1	ADDENDUM 1	9/9/2015
Number	Revision	Date

Job #	1505
Project	2ND FLOOR RENOVATION
Drawn By	Checked
Date	SEPTEMBER 14 2015
Scale	As indicated

PANTRY DETAILS

5 DOOR FRAME DETAILS
3" = 1'-0"

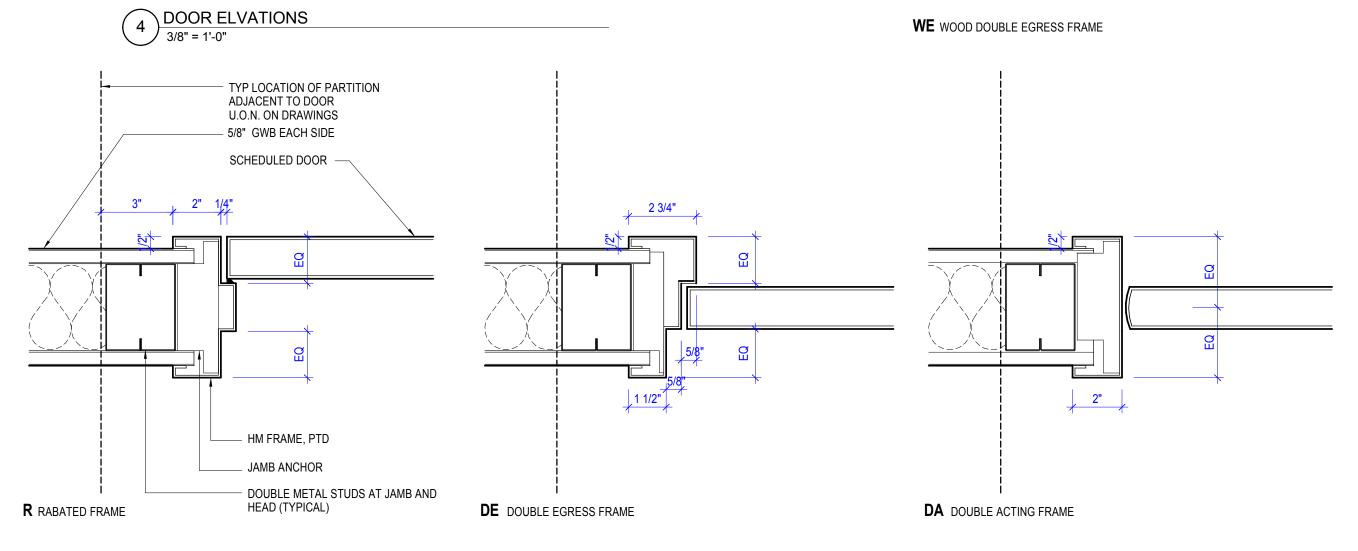
NOTE 1: MODIFY EXISTING CLOSER POCKET TO ACCOMMODATE NEW CLOSER NOTE 2: MODIFY EXISTING RABATED CASING TO DOUBLE EGRESS CASING
